NORANN SUBDIVISION AREA ROAD RECONSTRUCTION
PM&E PROJECT NO. 20-14

Draft DSM Review Comments and Responses

Review Comments & Responses

Project Name: Norann Subdivision Area Road Reconstruction	Project No: 20-14
Project Status: <input checked="" type="checkbox"/> Draft DSM <input type="checkbox"/> 35% <input type="checkbox"/> 65% <input type="checkbox"/> 95% <input type="checkbox"/> Other	
Reviewer Name/Title: Summary of Review Comments & Responses	
Organization / Department: Varies	
Phone Number: N/A	Date: Varies

FIGURE
M1

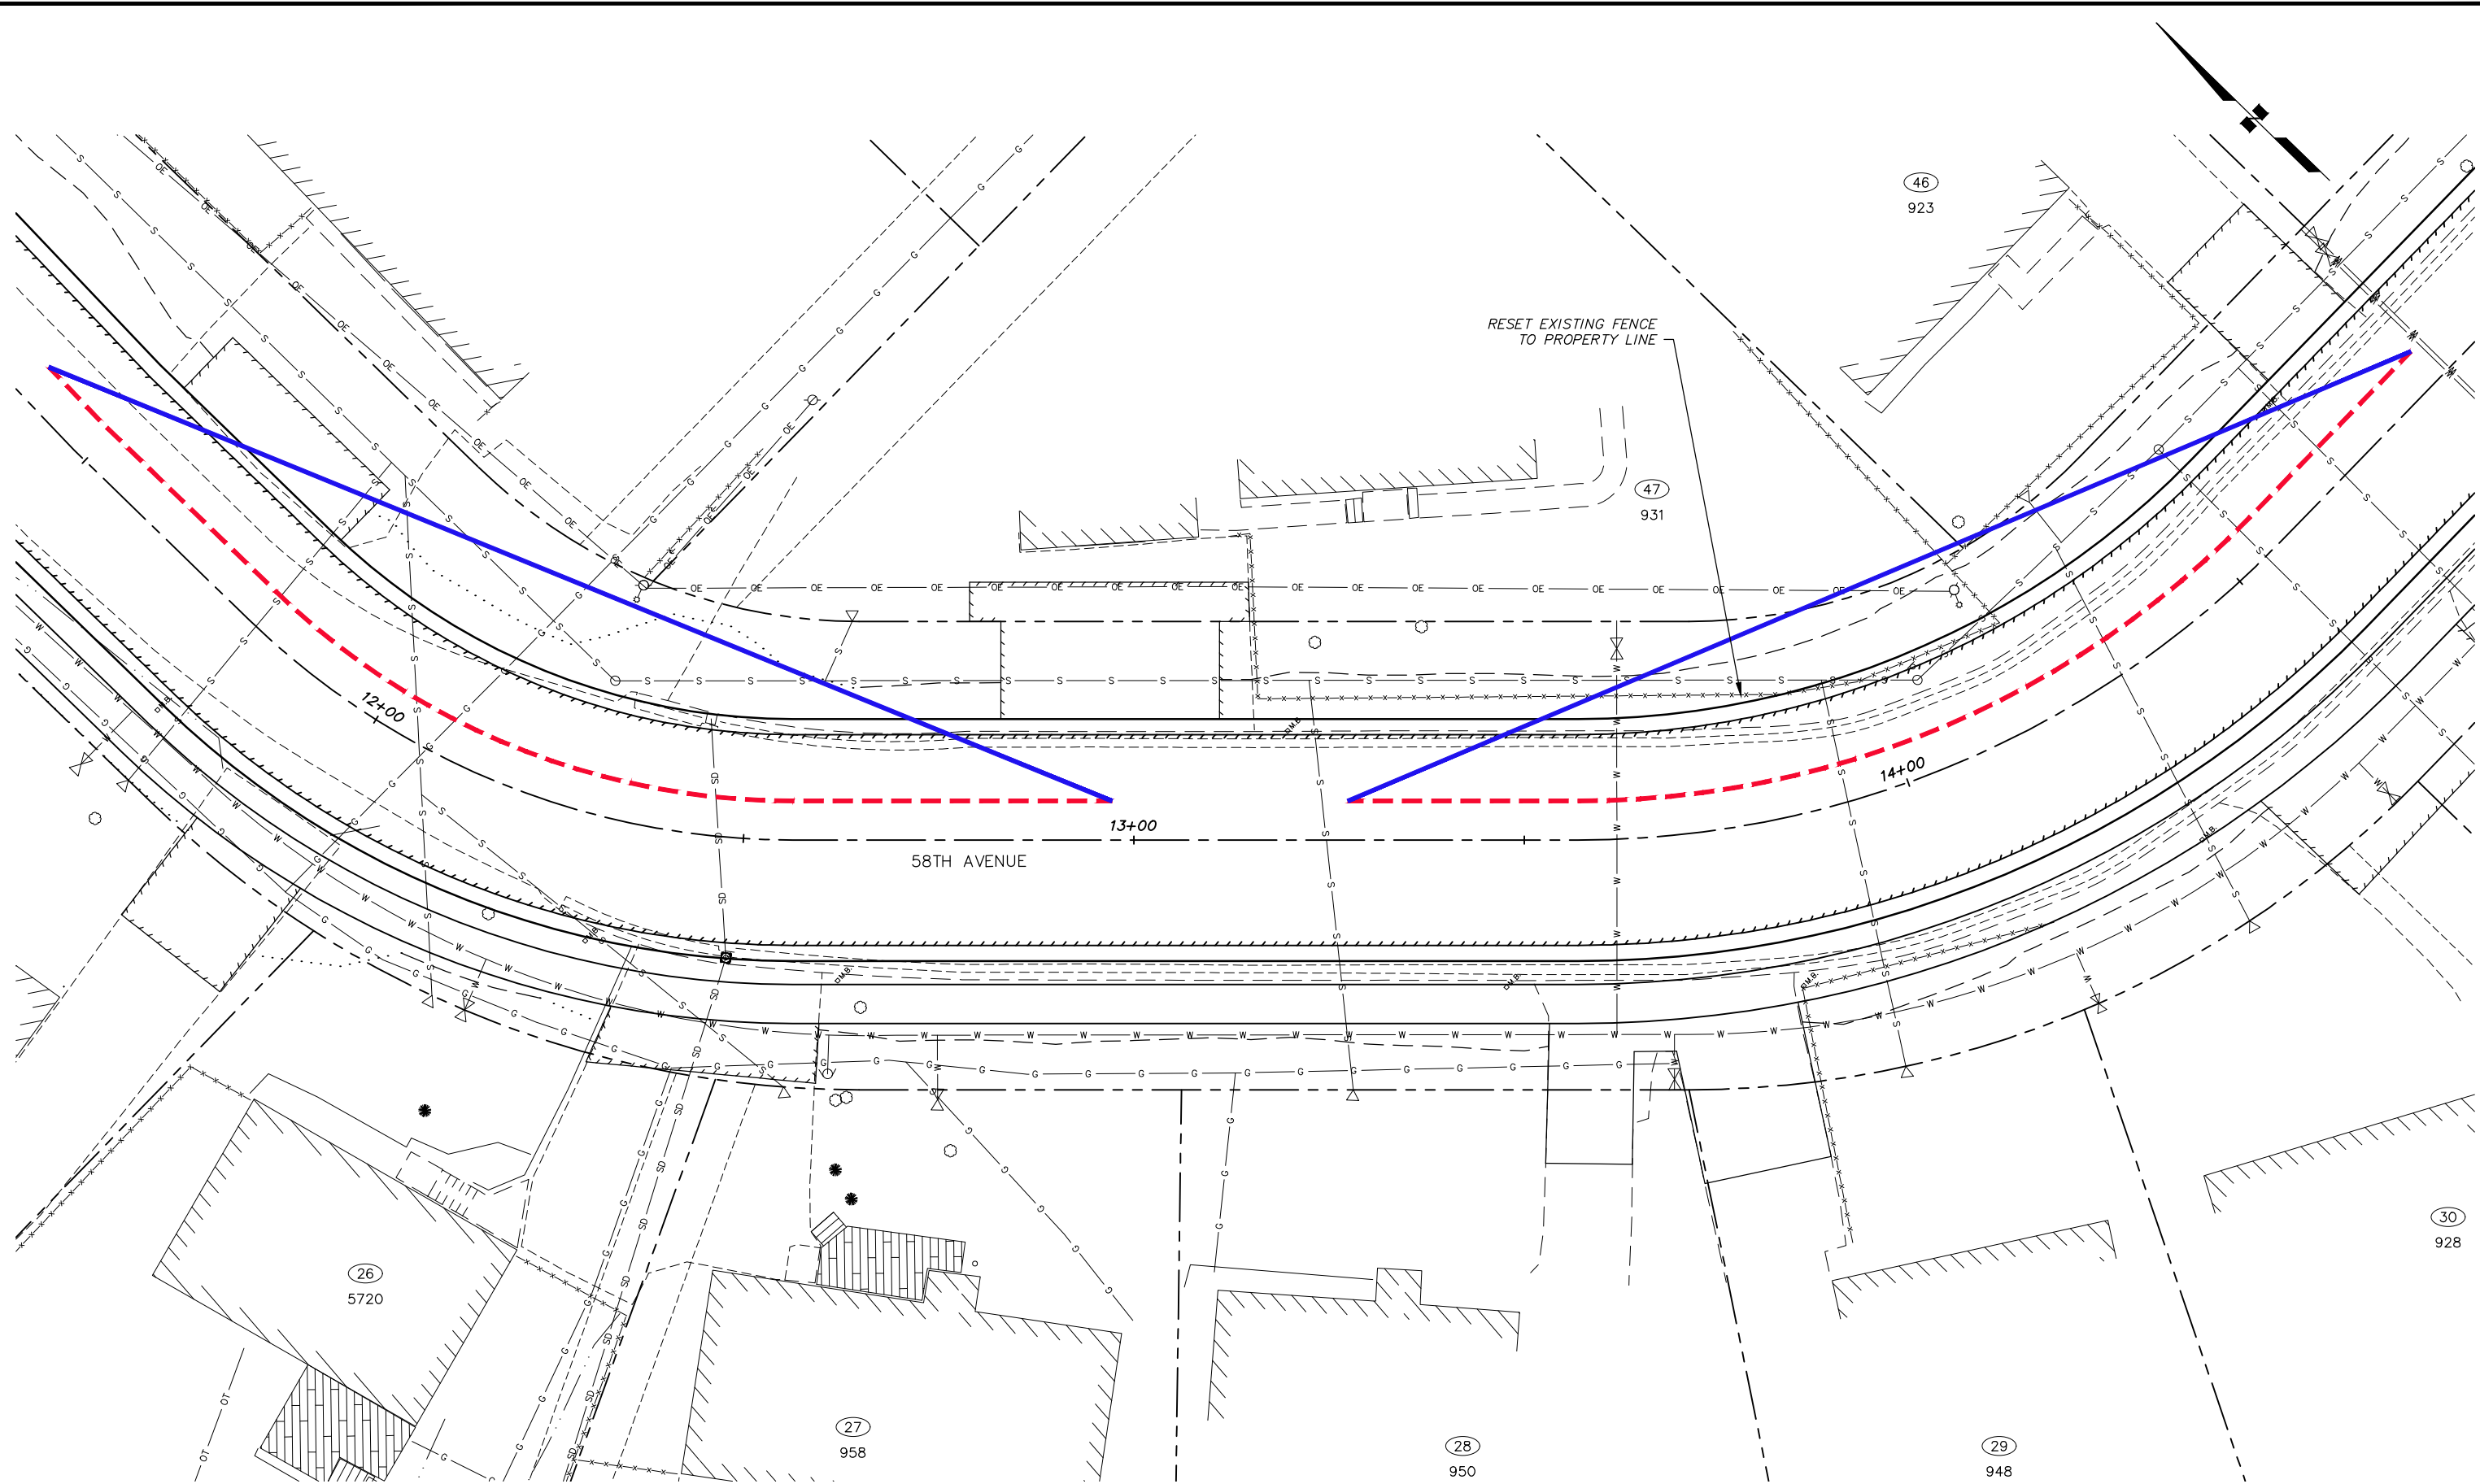
Reviewer	Dept.	Date	Page/ Sheet No.	Comment	Draft Response
7)	Kim for VanLanding ham	Street Maint.	7/10/23	Pg. 301	Is sight distance a concern along Arctic Boulevard at the W 57th Avenue and W 58th Avenue approaches? The DSM does not seem to discuss much about it and was commented by the public of shrubs/trees blocking visibility.	Have included a stopping sight distance figure along the horizontal curves for Alternative 2 in the Final DSM in Appendix M and have included a writeup in Section 3.3 of the Final DSM. Some of the existing fences need to be reset out of the sight lines as shown on the figure.
